March 11, 2011

Carson Helicopters, Inc. is writing to the National Transportation Safety Board regarding the final report and findings of the NTSB on the Sikorsky S61N helicopter crash near Weaverville, California on August 5, 2008. By this letter Carson is hereby filing a Letter of Petition to review the findings in this accident. Carson contends that, A) there is new and additional information regarding contaminants in the fuel system that should be given careful consideration, and B) the Board was not given complete and accurate performance information for review in reaching its findings regarding aircraft flight performance.

Comments on the Gen Hel Simulation for NTSB by Sikorsky Aircraft

NTSB EDS spectrum of the straight fiber from N612AZ PRV contained major elemental peaks of silicon, aluminum and calcium with minor elemental peaks of iron, magnesium, carbon, and oxygen, consistent with e-glass. (direct from NTSB Materials report)

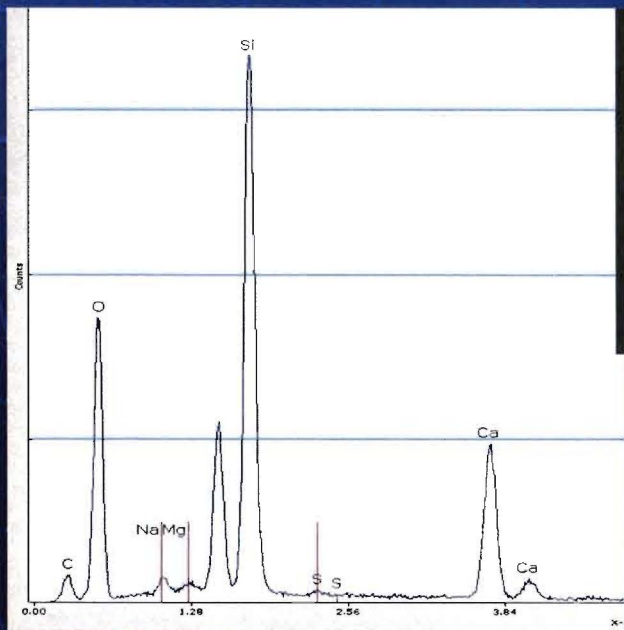
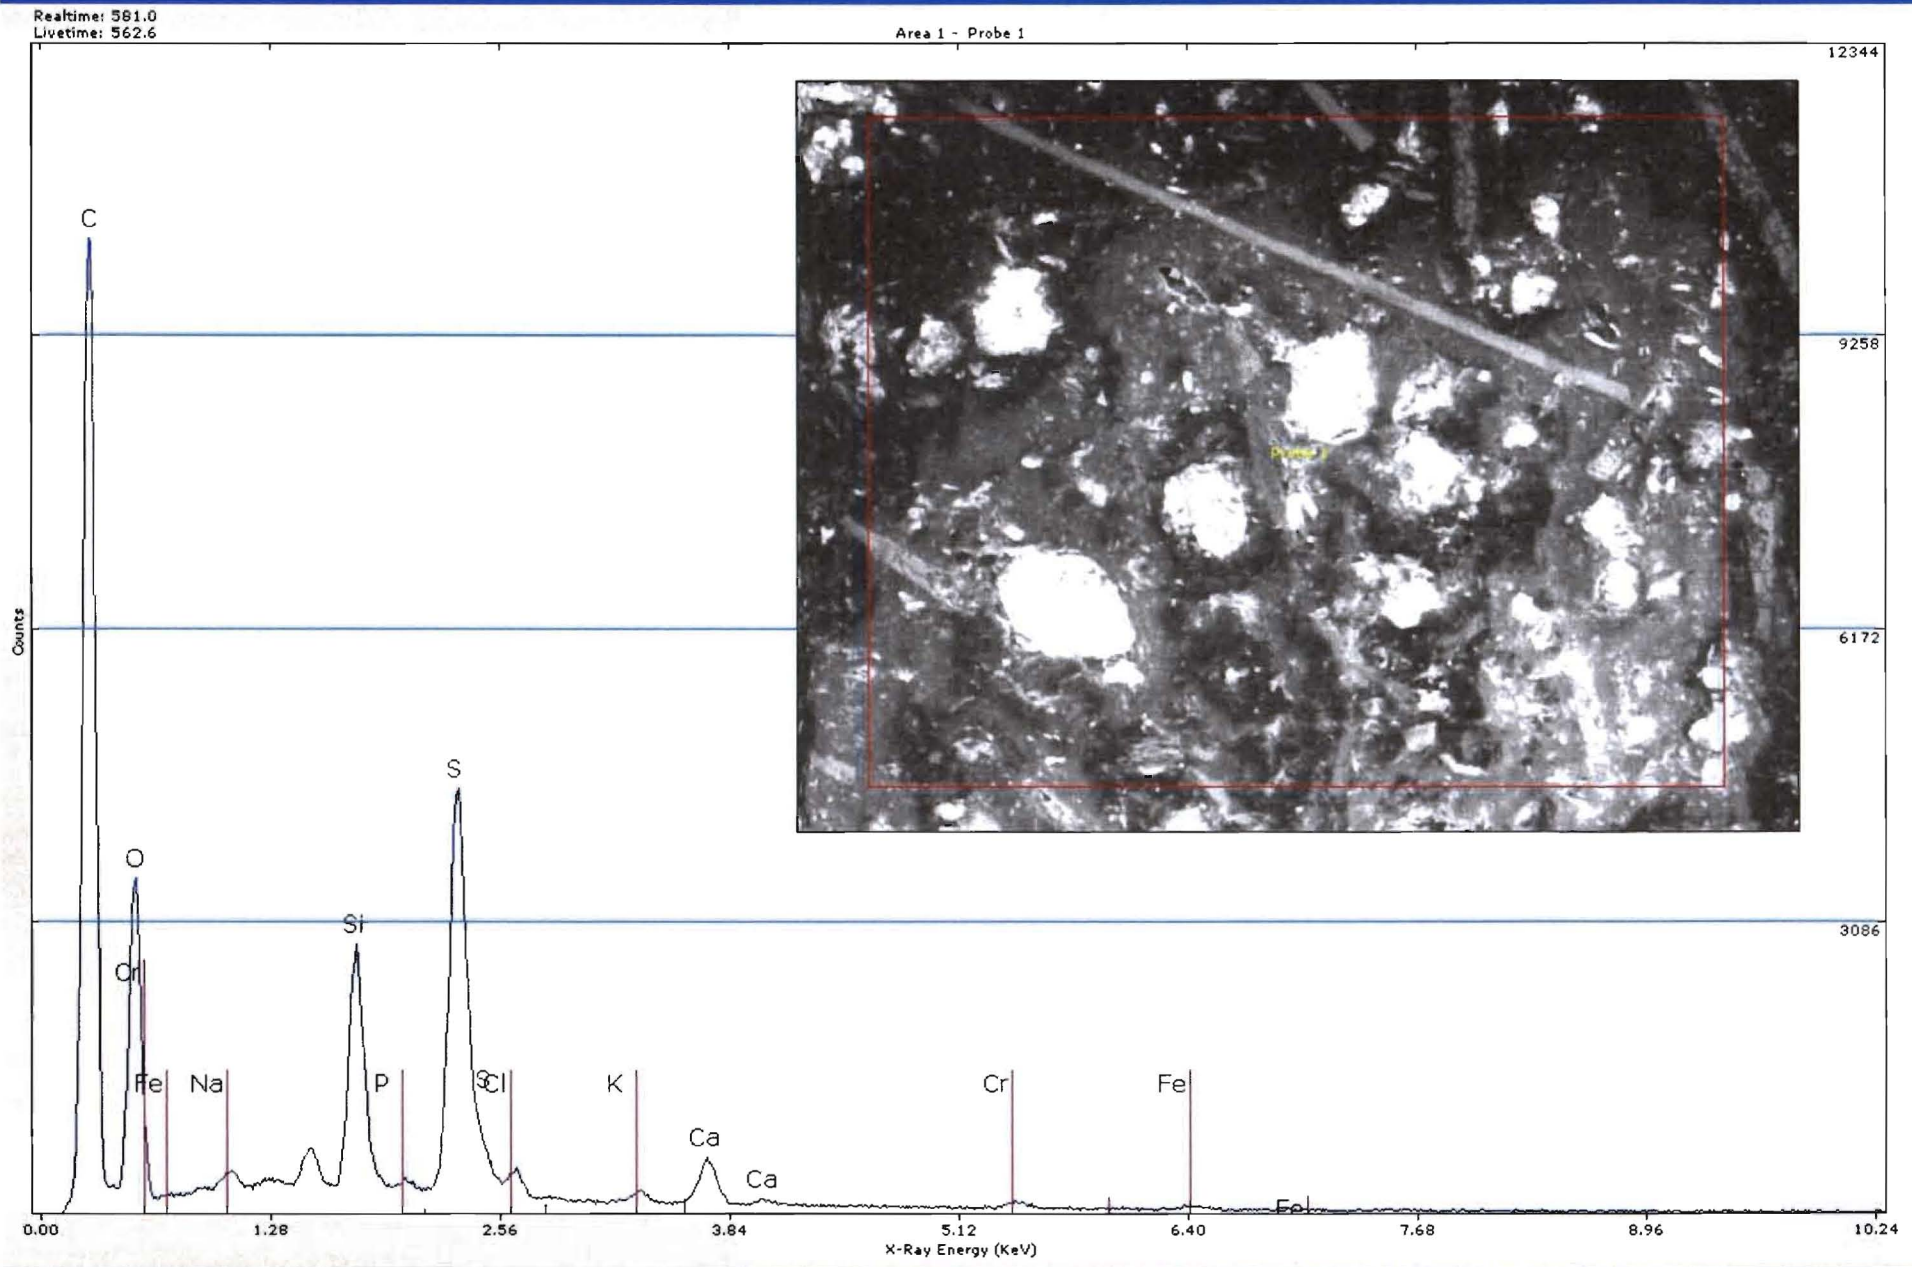
- b. Carson had a section of this coating examined at an independent laboratory via electron microscope and spectral analysis (*see attached photo section*). The coating contains long fiber particles and irregular flat particles that have spectral element peak signatures and physical characteristics that are nearly identical with the particles found in the FCU of N612AZ.

- c. The long strand fibers found in every contamination sample in NTSB possession are (in Carson’s opinion and by data comparison) a remarkable match for the composition and size of the long strand fibers contained in the E-poly matrix. It should be noted that these contamination samples also match those from other FCU failures on non-Carson aircraft.

Virtual identical match.

Flat backing pieces
from E-Poly and
N612AZ

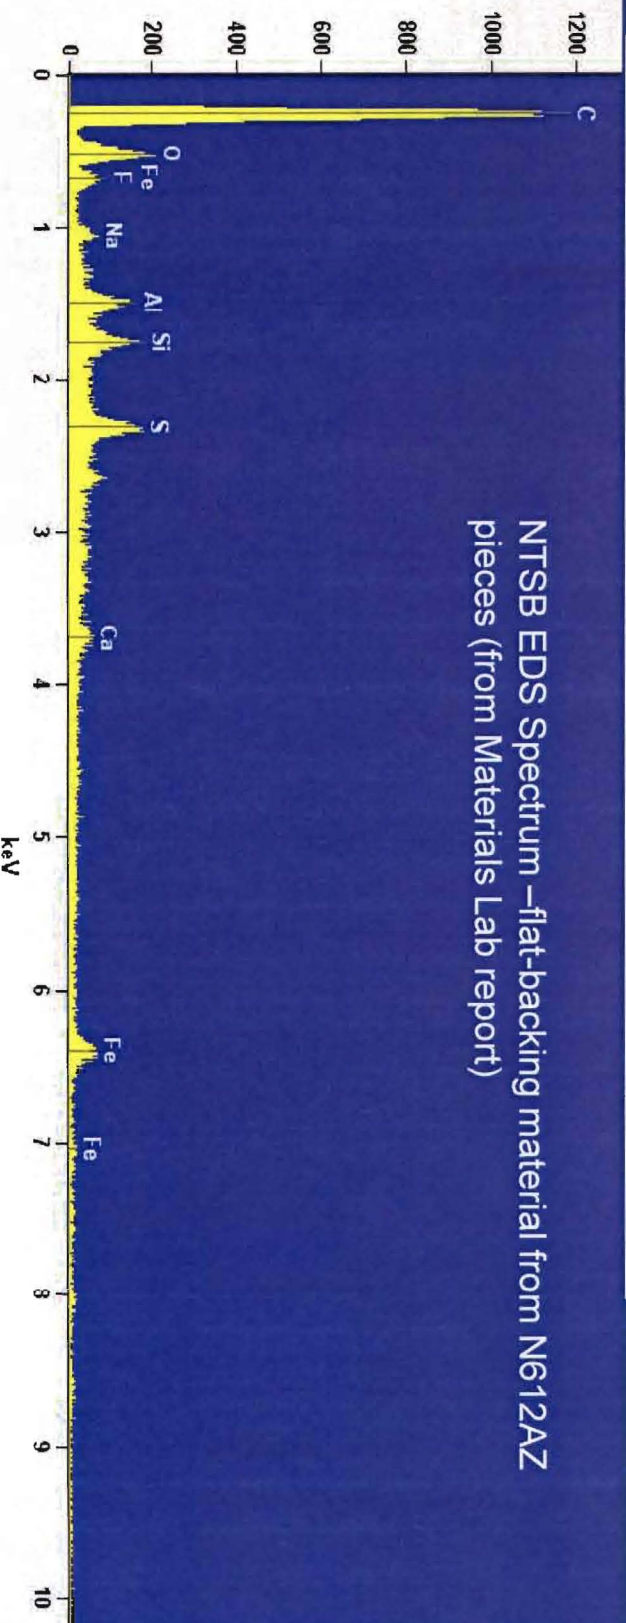
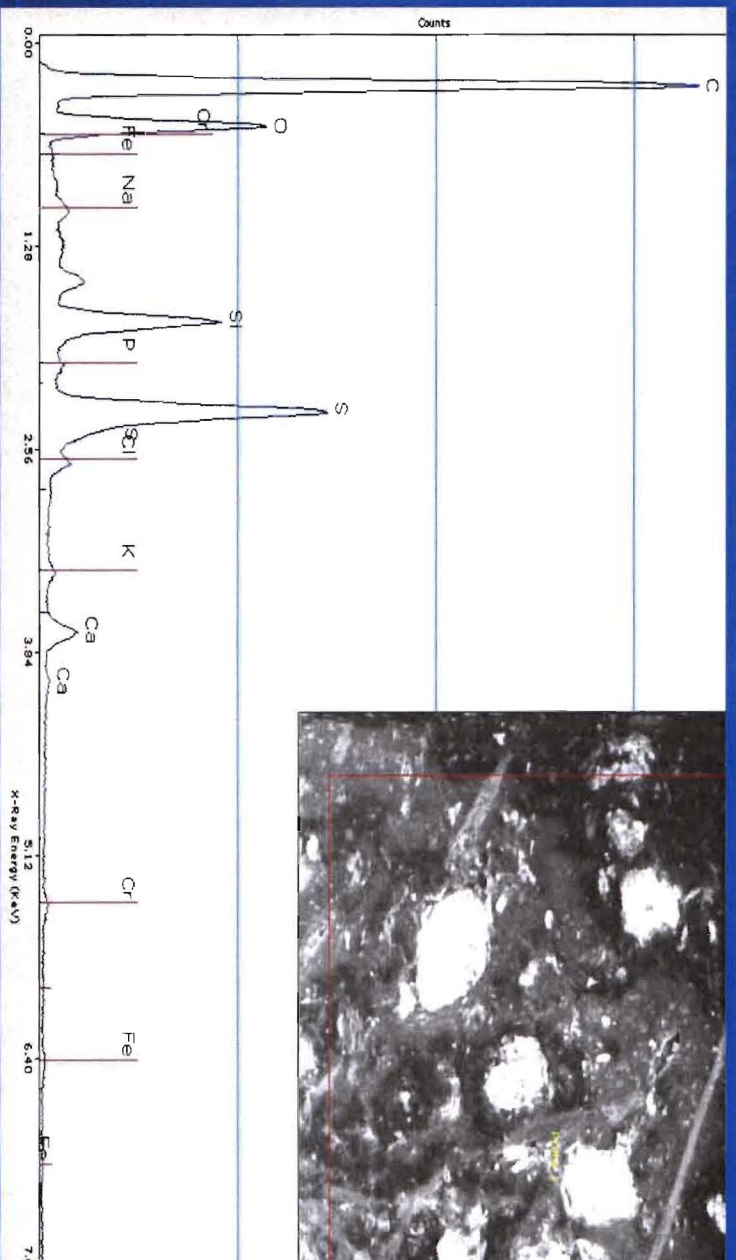
Extremely similar
Spectra match

Figure 9a.

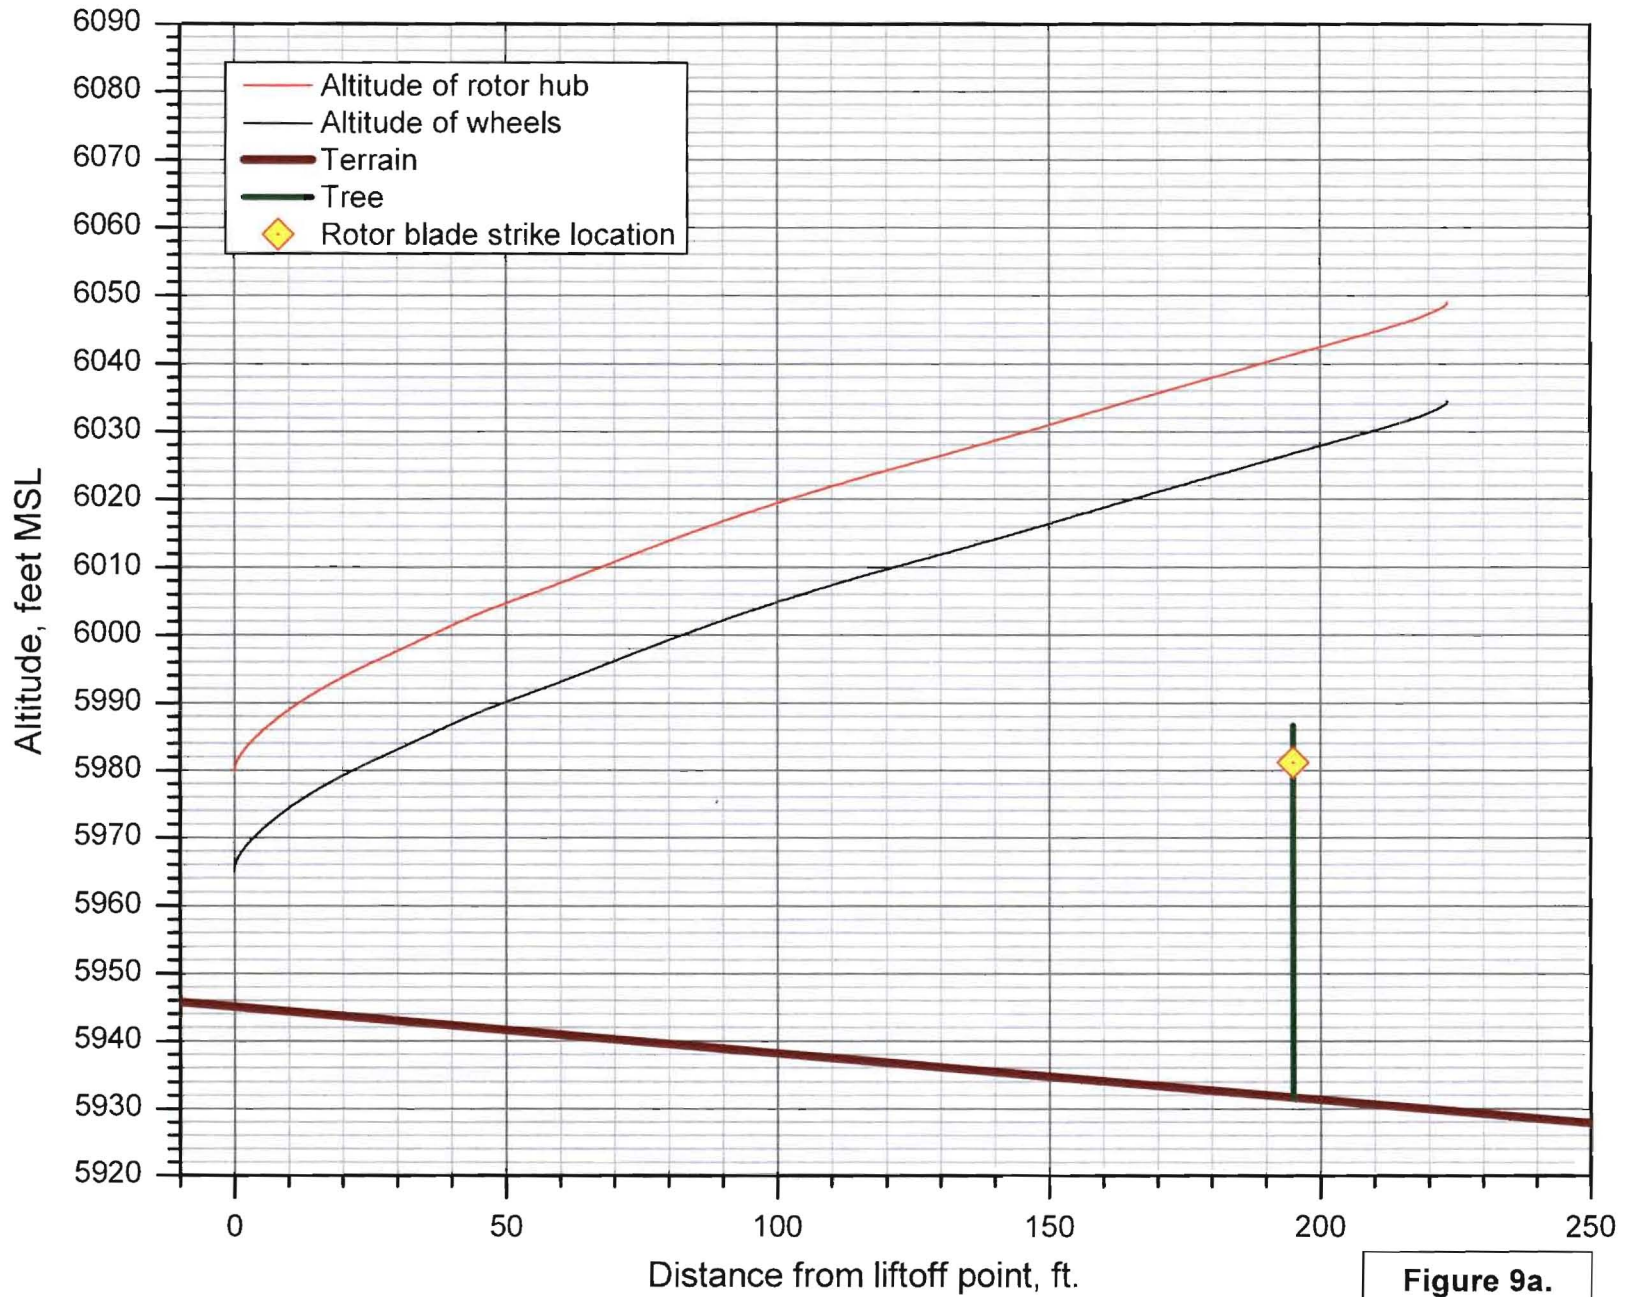
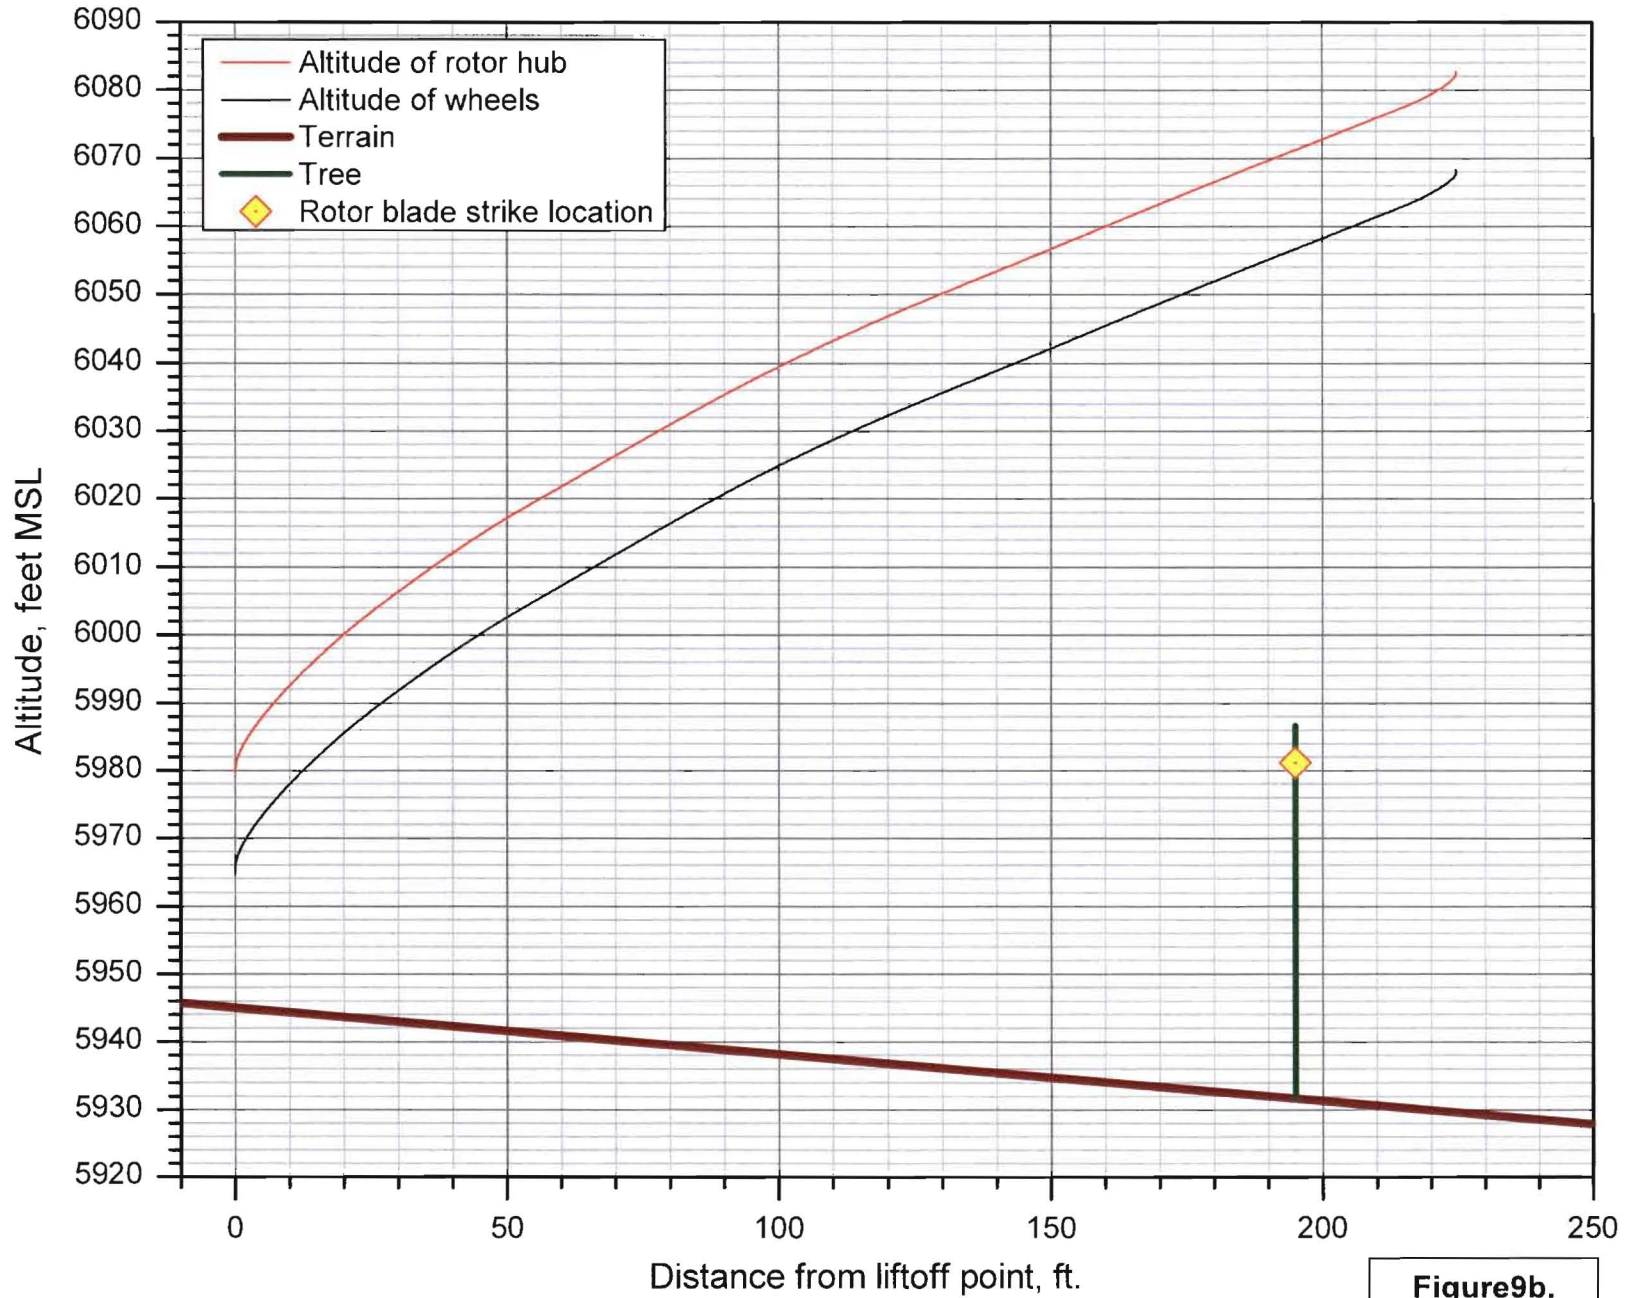
- b. The GenHel flight simulation that was done utilizing the FAA-approved performance for the aircraft clearly and conclusively shows that the S61 as equipped that day had more than adequate performance to clear the trees at the helipad H44, either at 20 deg. C or 23 deg. C (see attached simulation plots from NTSB Hover Study 9a, 9b). This data was not used or presented to Board members at the hearing.
